Phase One of the Upper Brook Street Masterplan

Response to Comments from Manchester City Council Highway Officers and Active Travel England on Planning Application

14 November 2023 version 1.0

VEHICLE TRACKING
MCC REFUSE/ LARGE RIGID (10m)
VEHICLE TRACKING TO LIFE SCIENCES
SERVICE YARD

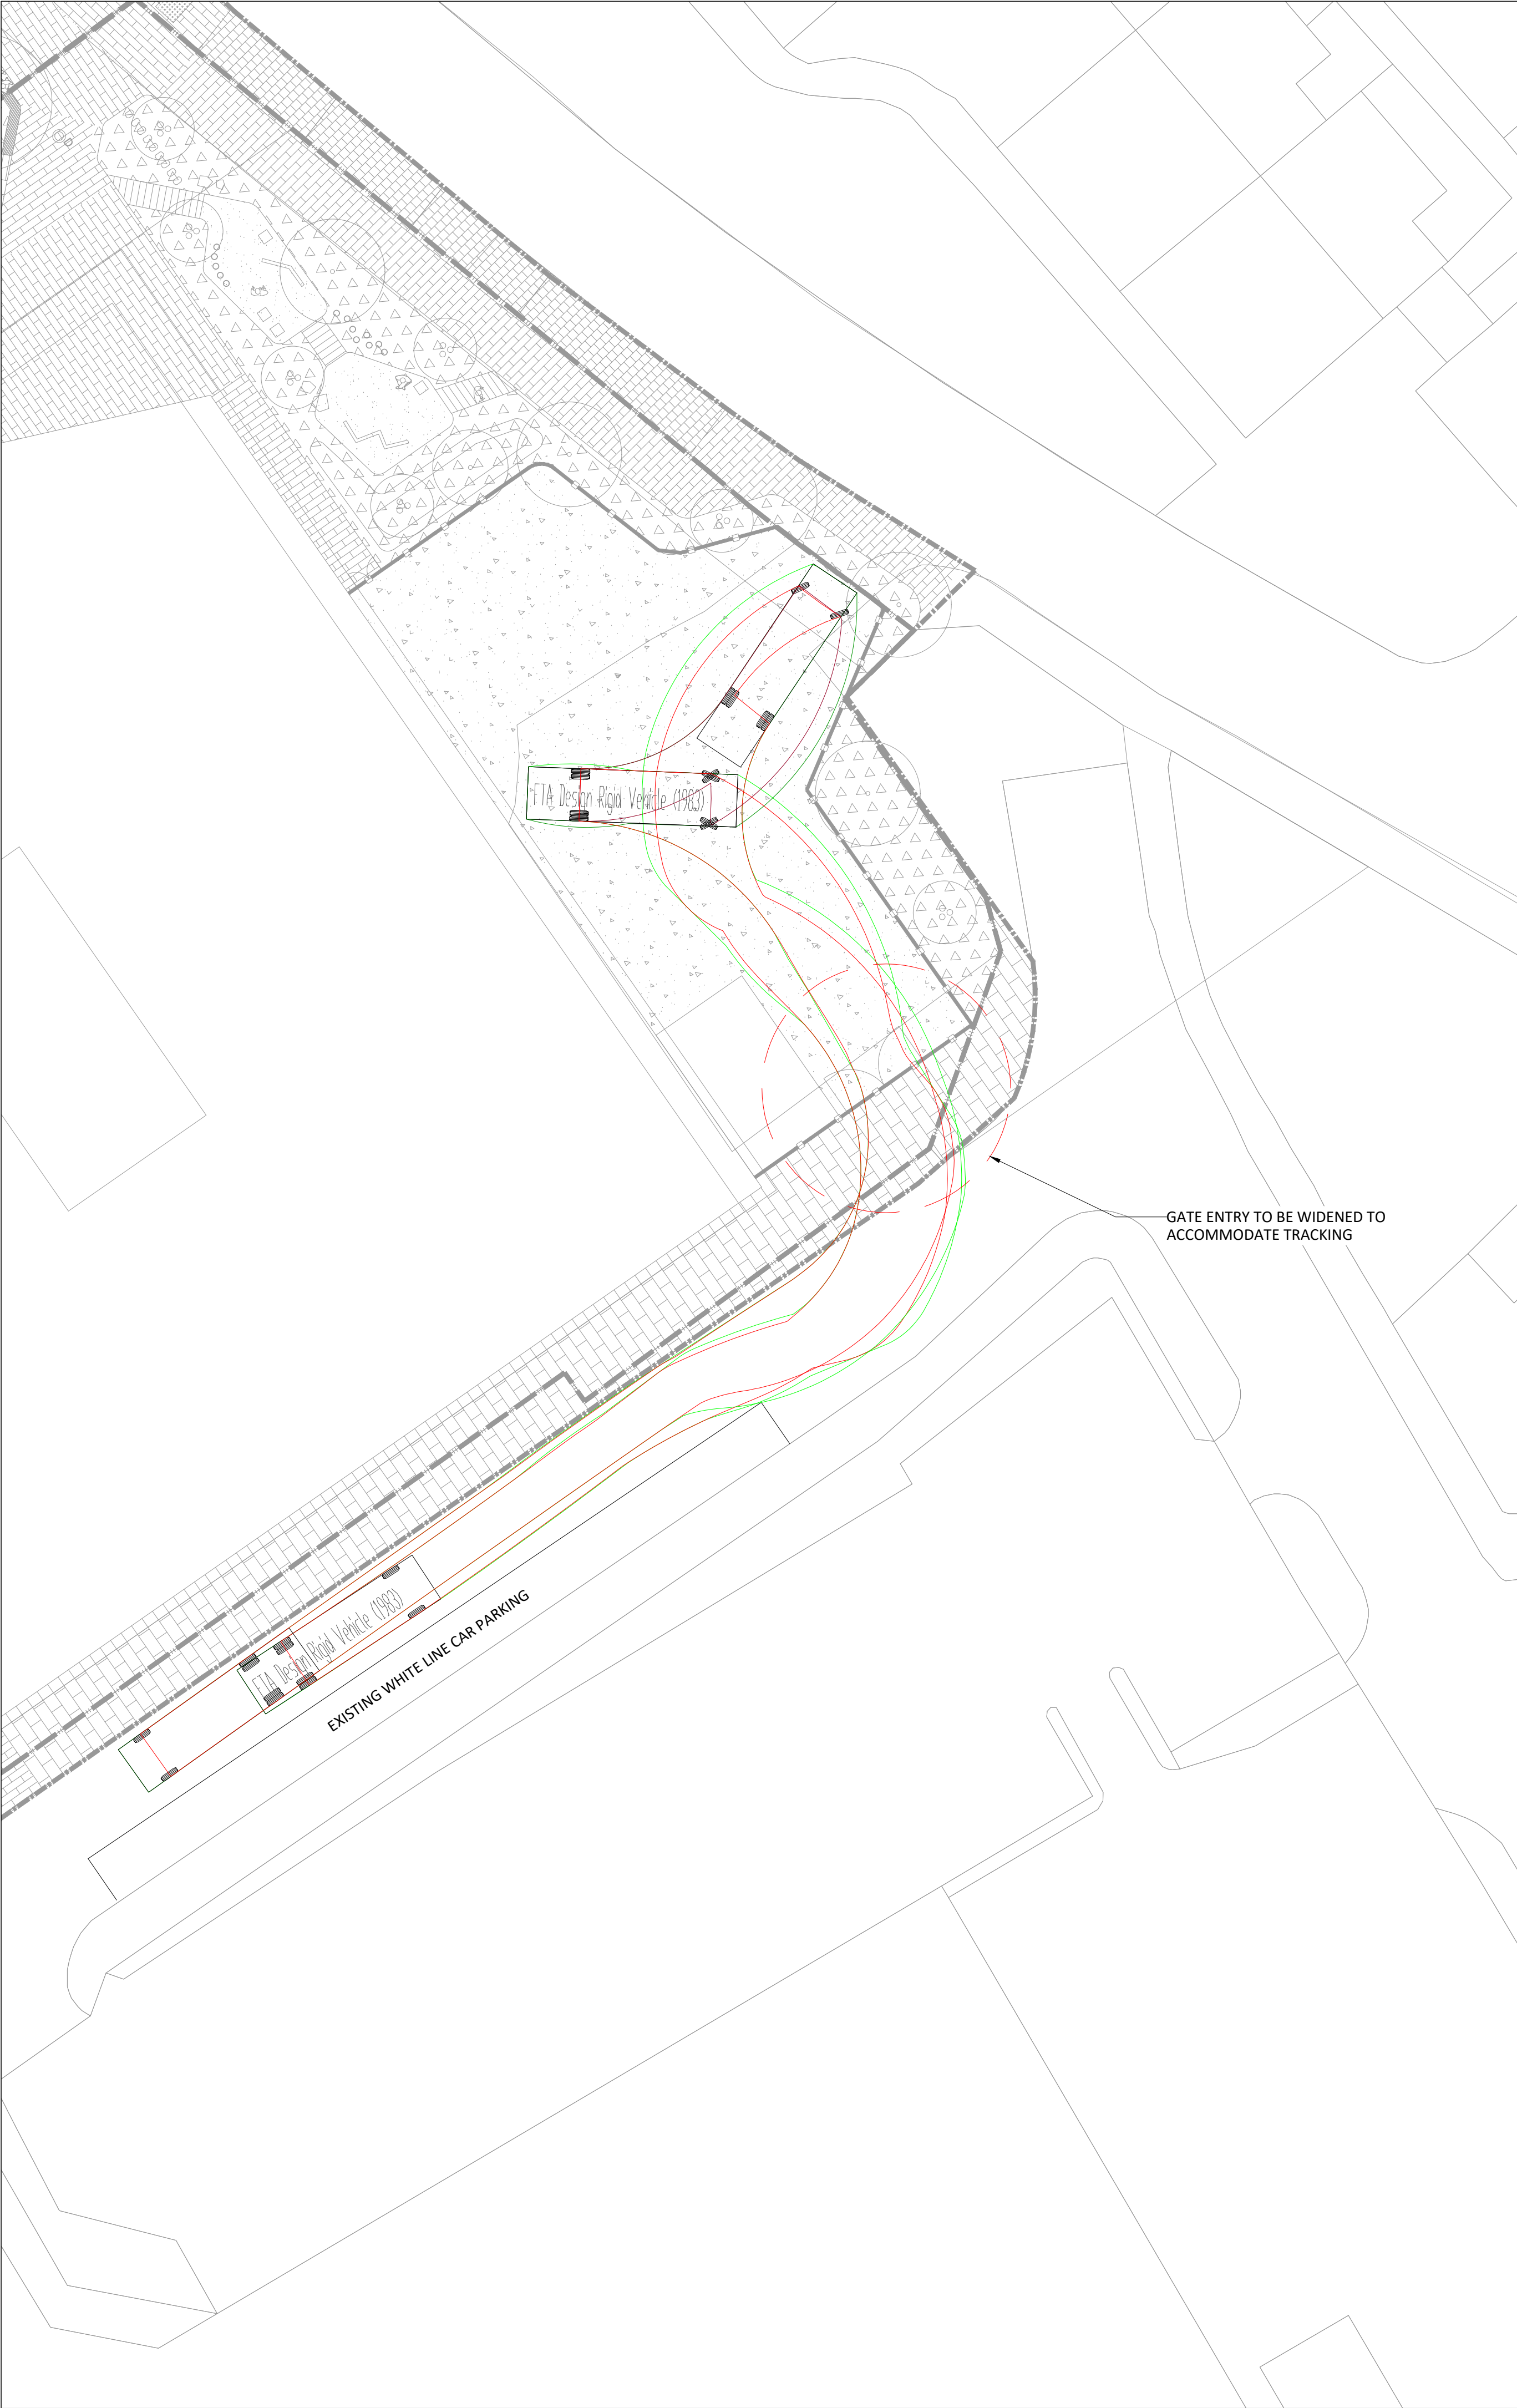
MCC Highway Officers Comments	Civic Engineers' Response:
loading bays would also work to ensure efficient servicing operations. The strategy should also ensure that vehicles utilising the Sci-Tech service yard are of a dimension to allow access and egress from Cottenham Street in forward gear.	building can turn around within the yard and exit in forward gear. Tracking was provided on drawing 2584-CIV-XX-XX-S-H-40013 in the Transport Assessment and is re-provided here.
Detail regarding management arrangements for the PBSA loading bay should be included as clearance will need to be maintained to cater for infrequent plant maintenance movements. Such movements would also require banksman support as access will be required by reversing into the site from Kincardine Road.	It is expected that a management strategy will be conditioned which will include these points.
The strategy should also take into consideration food/parcel deliveries, particularly for the proposed student accommodation, providing clear direction on the following: - o Designated delivery drop-off points: This could be a specific lobby area or a central location easily accessible to delivery drivers. - o Provision of clear signage in common areas to guide delivery drivers to the drop-off point. - o Inform all new residents on the designated drop-off point and any specific rules or guidelines they need to follow when receiving deliveries. - o Establish specific delivery hours for residents of the development where possible.	All deliveries will be to the reception desk via the main entrance for operational and security reasons. As above The Travel Plan will be updated pre-occupation to include information about deliveries being collected from reception will be provided. Based on experience at other student accommodation sites, it is not possible to specify times with delivery companies or for management to enforce a policy even if it was in place.

A new (full) loading bay is proposed on Kincardine Road to cater for refuse collections and deliveries associated with the student accommodation. Bins will be transferred from the PBSA building along via North West Road for servicing. Highways request that bins are stored in a holding area located within the site boundary prior to servicing and should not be placed onto the adopted footway for servicing.	See attached architects' plan from the Design and Access Statement which indicates where the holding area is to avoid bins blocking the footway on collection day.
Time-limiting traffic regulation order across the proposed	Tracking of Sci-tech service yard shows that all vehicles that need to serve the
